From: Selim <Selim@sawayaeng.com>
Sent time: 06/18/2019 08:02:35 AM
To: Ron Dragoo
Cc: So Kim; Jill Martin <jmartin@trumpnational.com>; Ara Mihranian; Scott Campbell <scampbell@trumpnational.com>
Subject: 2019-06-18 # Tract 50666 # Request for Storm Drain Amendment
Attachments: 2019-06-17 SD Request2City.pdf

Re: **Request to use Forestall Canyon to convey off-site storm water in lieu of the proposed 60 inch Reinforced Concrete Pipe.**

EXHIBIT "A"
TRACT 50666
PRE-DEVELOPMENT
EXISTING STORM DRAIN

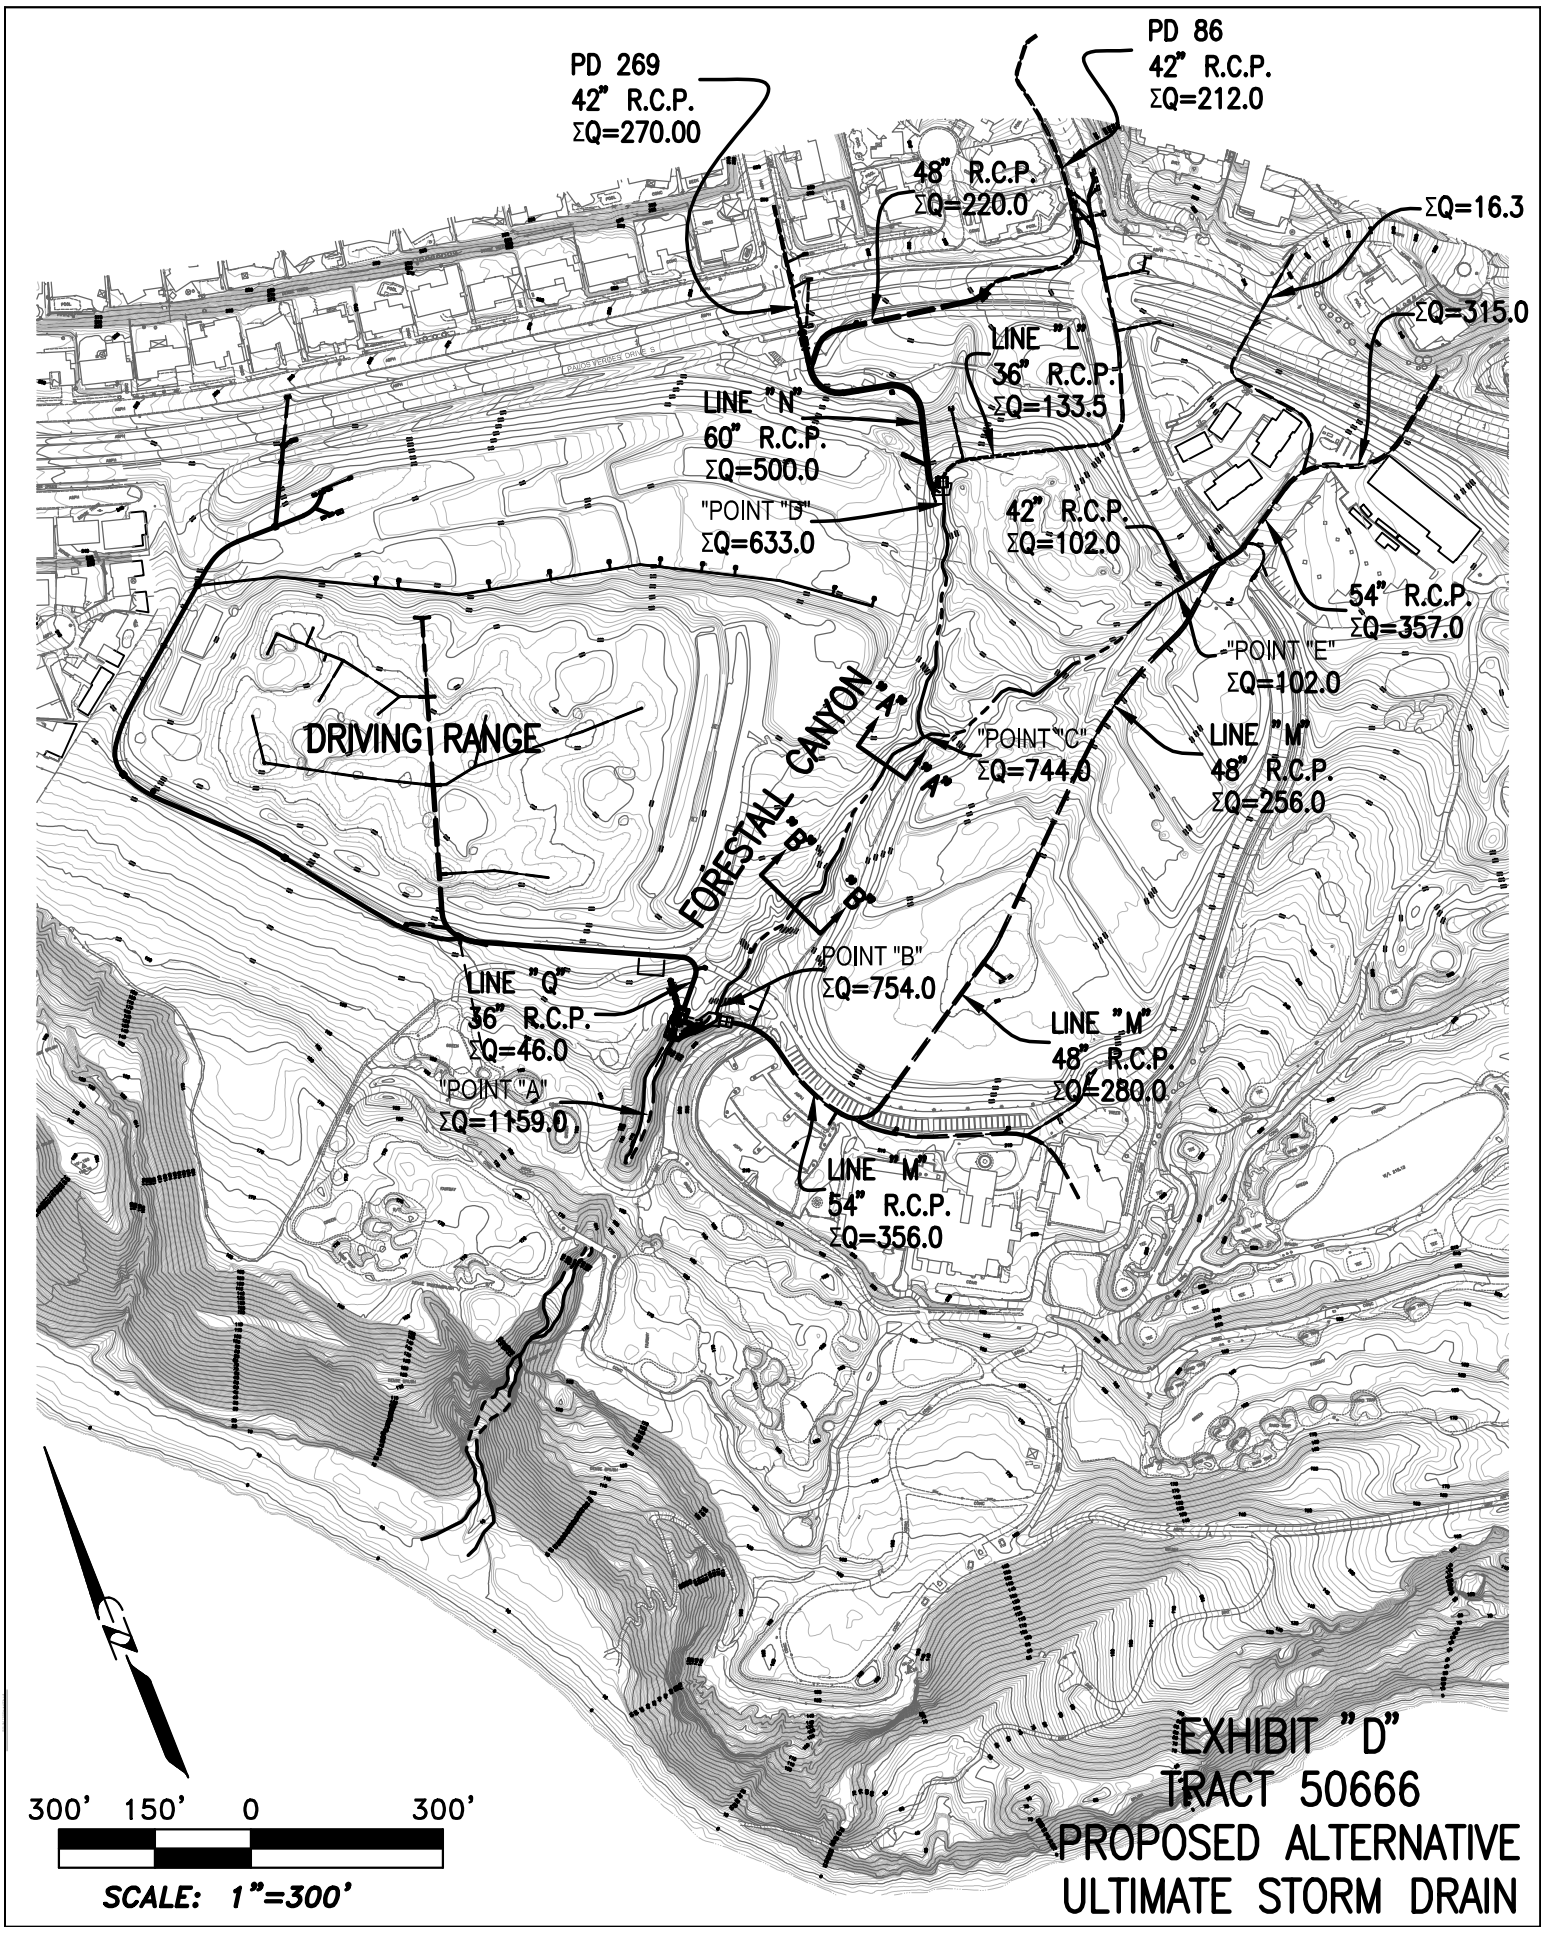
In 2005, an amended loting configuration for the site was approved and graded to provide for a driving range in lieu of 16 residential lots, thus reducing the number of residential lots west of Forestall Canyon from 29 to only 13 lots. The amended site as approved and graded has reduced and likely eliminated the risk of residential flooding from Forestall Canyon rendering the proposed Line "N" (60" RCP) redundant and unnecessary. Therefore, VH Property is requesting the City of Rancho Palos Verdes' approval to eliminate the portion of Line "N" that is adjacent to Forestall Canyon from Point "B" to Point "D".

1. The proposed ultimate flow of Forestall Canyon would be approximately 72% of historical (Predevelopment at Point "B" is 1050 cfs – Post development at Point "B" is 754 cfs).
2. The proposed ultimate flow of Forestall Canyon would be equal to the current/interim flow.
3. Forestall Canyon has performed well under the current/interim condition for the past 15 years.
4. No Residential lots would be at risk from flooding and high velocity scouring action.
5. Forestall Canyon has the capacity to carry the anticipated flow with a velocity less than 15 fps. (See Exhibit "E" for Hydraulic Calculation).
6. Since PD 86 and PD 269 are debris carrying line, Forestall Canyon is more suitable to carry the flow rather than a storm drain pipe.

7. The construction of Line "N" is very intrusive to the area due to its size (60") and depth (20').
8. Line "N" if constructed would be a debris carrying line with a pipe diameter of 60 inch at a minimum slope of 5%, carrying a flow of 549 cfs, resulting in a velocity of at least 38 fps. This would require a large outlet structure / riprap pad configuration which would be intrusive to the ecosystem of Forestall Canyon.
9. The Operator of the Golf Course is bound by a maintenance agreement with the City of Ranch Palos Verdes, which covers the extent of maintenance liability over Forestall Canyon and all outlet structures.

EXHIBIT "E"
TRACT 50666
PROPOSED ALTERNATIVE
HYDRAULIC CALCULATION

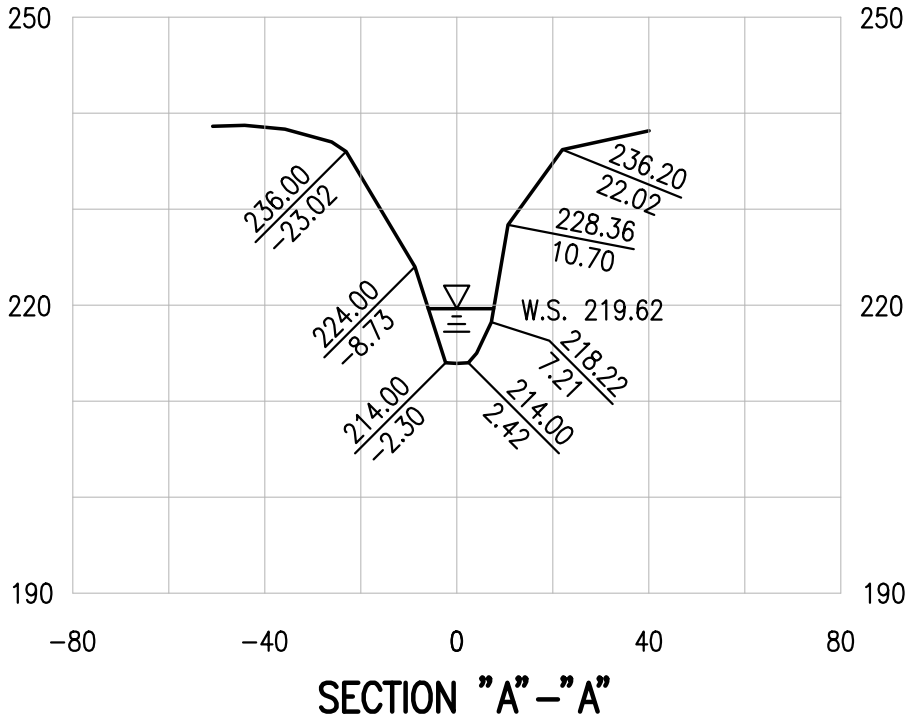
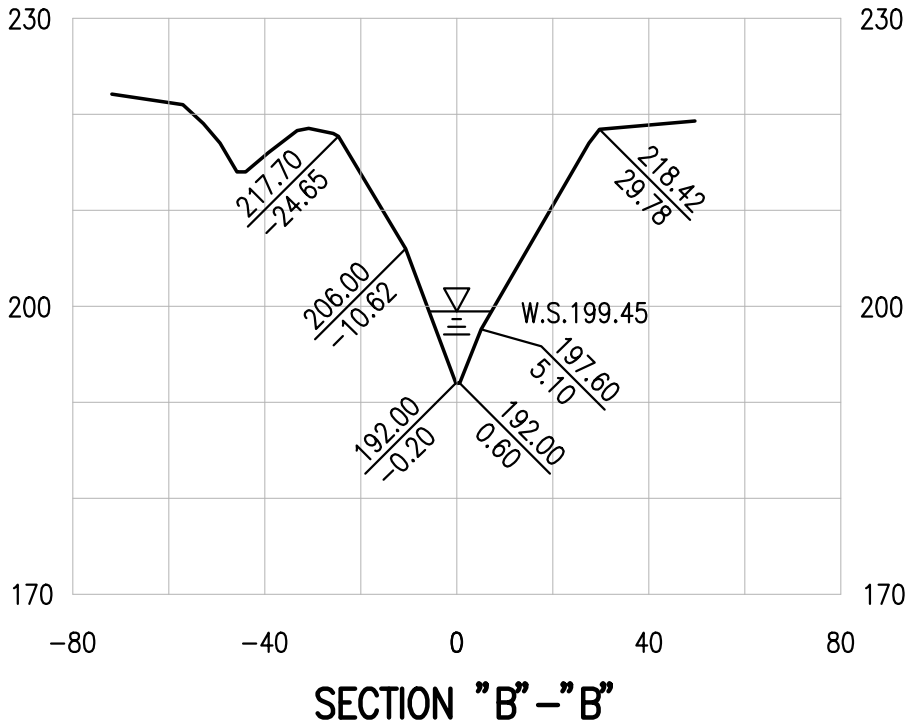
INPUT DATA
Channel Slope 0.043500 ft/ft
Elevation range: 214.00 ft to 236.20 ft.
Discharge 735.00 cfs

RESULTS
Wtd. Mannings Coefficient 0.045
Water Surface Elevation 219.62 ft
Flow Area 53.81 ft²
Wetted Perimeter 19.26 ft
Top Width 13.60 ft
Height 5.62 ft
Critical Depth 220.21 ft
Critical Slope 0.029653 ft/ft
Velocity 13.66 ft/s
Velocity Head 2.90 ft
Specific Energy 222.52 ft
Froude Number 1.21
Flow is supercritical.

INPUT DATA
Channel Slope 0.064000 ft/ft
Elevation range: 192.00 ft to 218.42 ft.
Discharge 754.00 cfs

RESULTS
Mannings Coefficient 0.045
Water Surface Elevation 199.45 ft
Flow Area 49.53 ft²
Wetted Perimeter 20.13 ft
Top Width 13.03 ft
Height 7.45 ft
Critical Depth 200.50 ft
Critical Slope 0.032121 ft/ft
Velocity 15.22 ft/s
Velocity Head 3.60 ft
Specific Energy 203.05 ft
Froude Number 1.38
Flow is supercritical.
